# **FREDERICK COUNTY PLANNING COMMISSION**

**January 8, 2014**

**TITLE:** Landon House Complex

**FILE NUMBER:** SP-98-29, AP# 13837, FRO# 13839, SWM# 13838

EXHIBIT 1- Concept Site Plan  
EXHIBIT 2- Proposed Subdivision Strategy

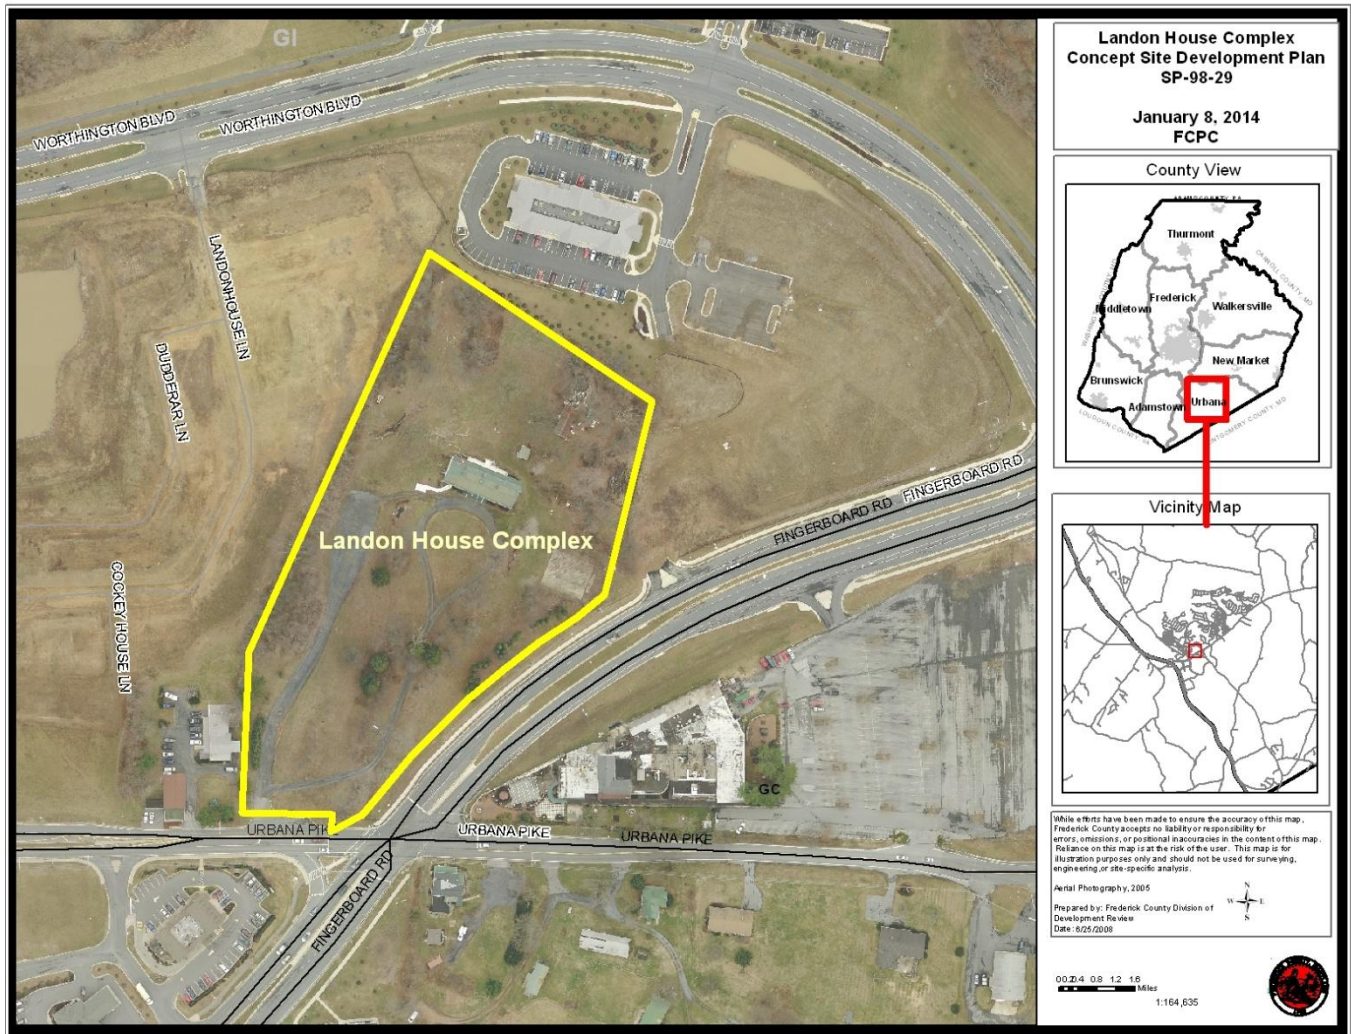
- With no community or corridor plan in effect for the Urbana community, building massing and bulk will be limited only by the underlying zoning regulations. In plan view, the new structures appear to compete with the Landon House. It is likely that a study of the massing and site placement of the three new structures located along the property's western edge will reveal that their visual impact on the main house will be minimal. An appropriate architectural response to the placement and scale of Building E may include reducing the overall size of the building, shifting its location on the Site, altering the configuration of the building, or deploying specialized architectural treatments or elements that demonstrate visual subservience to the main house. In all cases, the primary goal of Staff throughout the review process will be to protect the character of the Landon House by ensuring that any design or engineering approach respects this building's preeminence on this Site.

- The Landon House structure, with its proposed Banquet Hall expansion, would measure approximately 70 s.f. above the permitted 10,000 s.f. maximum building footprint in the Village Center district. The Planning Commission may approve buildings with a footprint above 8,000 s.f. in growth areas only. The Applicant must demonstrate how their proposed structure meets the criteria for such an increase in the building footprint as listed in §1-19-7.500.(4)(d) of the Zoning Ordinance

The Applicant proposes to retain 3 of the 4 specimen trees. However; the proposed development layout shown on the Concept Plan fails to adequately protect the 3 specimen trees. When protecting a specimen tree, the tree’s critical root zone (CRZ = a diameter equal to 1 foot for each inch of tree diameter) must be left substantially undisturbed. No more than 30% of the CRZ can be disturbed.

- 53” Red Oak: This significant tree is located in the rear of the existing Landon House. Nearly 100% of this tree’s critical root zone will be disturbed based on the Concept Plan layout. The grading proposed within 20 feet of the tree must be eliminated. The proposed 12’ x 50’ loading space must be eliminated, the proposed retaining wall must be relocated approximately 20 feet to the north and east, and the proposed parking, drive aisle, and water and sewer lines must be adjusted.
- 30” Tulip Poplar: This tree is located on the east side of the circular driveway. Approximately 60% of this tree’s CRZ will be disturbed based on the Concept Plan layout. Although the existing driveway is situated within this tree’s critical root zone, the Concept Plan does not illustrate if

earth disturbance is required for the widening of the lane. This impact, as well as the impact of the proposed entrance serving proposed Building E must be further evaluated and, if necessary, redesigned to limit the impact to the CRZ. The western edge of the existing driveway should be held and any proposed widening should occur on the east side of the existing driveway, further away from the tree.

- 32" Basswood: This tree is located between proposed Building B and the circular driveway. Approximately 30% of this tree's CRZ will be disturbed based on the Concept Plan layout. Removal of 3 parking spaces and a slight shift of the proposed SWM infiltration system will drastically reduce the impacts to this tree.
- 30" Silver Maple: This tree is located in the Northeast corner of the property and is located within a proposed street that will serve the Landon House Site as well as Urbana Commons. At the time of site plan application, the Applicant must submit a modification request and document why the plan cannot be reasonably altered to save the tree.

- 1) Applicant will work to correct plan notes to reflect the latest iteration of the proposed concept site plan with particular emphasis on Notes #2 and #12. All references to land uses on the Site Development Plan shall reflect the specific uses as defined in §1-19-5.310 (Use Table) of the Zoning Ordinance.

- 2) The reconstructed stone chapel shall be sited as far to the west as possible to diminish the visual impact of this newly added structure along the front of the property.

- 5) Applicant shall clarify or correct the parking space calculation to reflect the total number of spaces provided on the Site, inclusive of handicap spaces. Any spaces provided above the number required by the Zoning Ordinance shall trigger the requirement for a Parking Modification request to be filed with the Site Development Plan application.

- 6) At the time of Site Development Plan application, the Applicant must address outstanding landscape requirements for screening parking areas, providing tree canopy shading of paved surfaces, and providing street trees appropriate to the Site given its historic significance.
